SUNDRY NOTICES AND REPORTS ON WELLS
Do not use this form for proposals to drill or to re-enter an
abandoned well. Use Form 3160-3 (APD) for such proposals.

MDA 701-98-0013		
	6. If Indian, Allottee, or Tribe Name		
J.	7. If Unit or CA/Agreement Name and/or No. 27474		
	8. Well Name and No.		
	Jicarilla 29-03-01 #2		
	9. API Well No.		
	30-039-26866		
	10. Field and Pool, or Exploratory Area		
	E. Blanco, PC/Cabresto Canyon Tertiary		
	11. County or Parish, State

Black Hills Gas Resources PC and OA P&A Procedure

JICARILLA 29-03-01 #2

Jicarilla 29-03-01 #2 Current WB Diagram

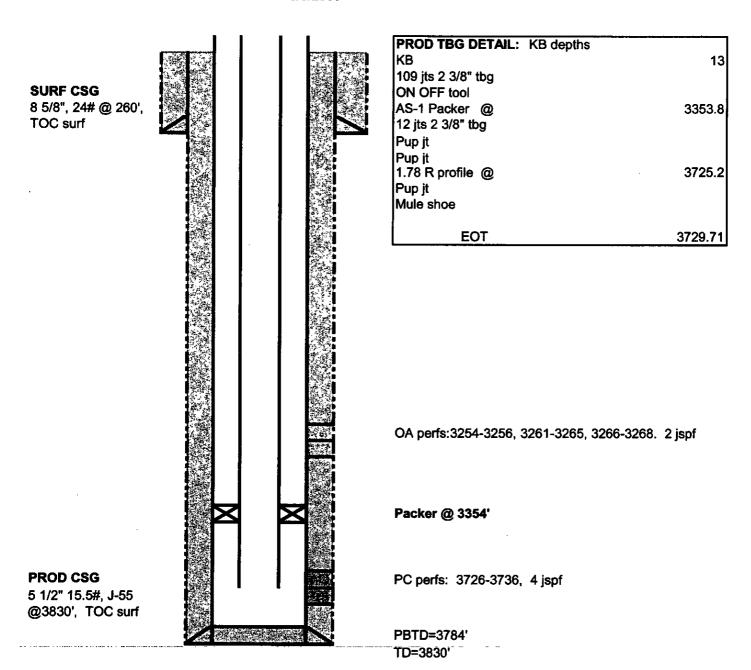
Proposed Work: Plugback well for the Jicarilla Tribe to use as water well.

- 5. Plug #1 (Pictured Cliffs, Fruitland, Kirtland and Ojo Alamo tops, 3736' to 3258'): TIH and set a 5.5" CR at 3600'. Pressure test the tubing to 1000 PSI. Mix and pump 63 sxs Type III cement, squeeze 28 sxs below the CR to fill the PC perforation and then spot 40 sxs above the CR to cover the Fruitland, Kirtland and Ojo Alamo formation tops. TOH with tubing.

- 6. Plug #2 (Nacimiento perforations, 3268' to 3150'): TIH and set a 5.5" CR at 3200'. Establish rate into the Nacimiento perforations (3254' to 3268'). Mix and pump 30 sxs Type III cement, squeeze 25 sxs below the CR into the Nacimiento perforations and then spot 5 sxs above to cover the CR. PUH to 3100' and reverse circulate the casing clean. TOH and LD the workstring.
